Access Compliance Report

Public Rights-of-Way

Intersection ID: 45183	Main Street: WESTON_GLEN_DR	Cross Street: COMMUNITY_HOUSE_RD	Location: NE
ADA ID: D0872D3F0B8F	Ramp Type: PerpDiag	Initial Pass/Fail: Fail	Overall Compliance: No
Severity Score: 8.75			
Codes/Mitigation Info/Possible Solution		Field Measurements/Component Compliance

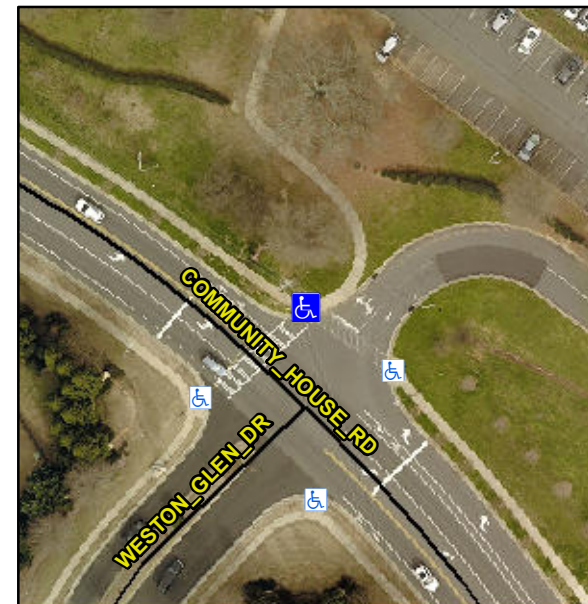
Not Found, R304.5.1

Compliance	Description	Data	Compliance	Description	Data
N/A	Ramp Length (in)	72.0	Yes	Ramp Slope (%)	7.0
No	Ramp Width (in)	41.5	Yes	Ramp XSlope (%)	0.9
N/A	Flare Type LT	N/A	N/A	Flare Type RT	N/A
N/A	Flare Slope LT (%)	N/A	N/A	Flare Slope RT (%)	N/A
N/A	Flare Traversable LT?	N/A	N/A	Flare Traversable RT?	N/A
N/A	Landing Length (in)	N/A	N/A	DWS Provided?	N/A
N/A	Landing Width (in)	N/A	N/A	DWS Contrast?	N/A
N/A	Landing Slope (%)	N/A	N/A	DWS Length (in)	N/A
N/A	Landing X Slope (%)	N/A	N/A	DWS Full Width?	N/A
N/A	Landing Curb? (Y/N)	N/A	N/A	DWS Offset (in)	N/A
N/A	Shared Landing?	N/A			
N/A	Gutter Ponding?	N/A	N/A	Gutter Slope (%)	N/A
N/A	Gutter Lip Ht (in)	N/A	N/A	Gutter X Slope (%)	N/A
N/A	Painted X Walk1?	Yes	N/A	Painted X Walk2?	Yes
	X Walk 1 Direction	To SW		X Walk 2 Direction	To SE
N/A	X Walk 1 Width (in)	112.0	N/A	X Walk 2 Width (in)	72.0
	X Walk 1 Slope (%)	3.0		X Walk 2 Slope (%)	0.4
	X Walk 1 X Slope (%)	1.4		X Walk 2 X Slope (%)	1.4

Remove & Replace Curb Ramp With Two New Directional Ramps or Equivalent. Restripe Crosswalk.
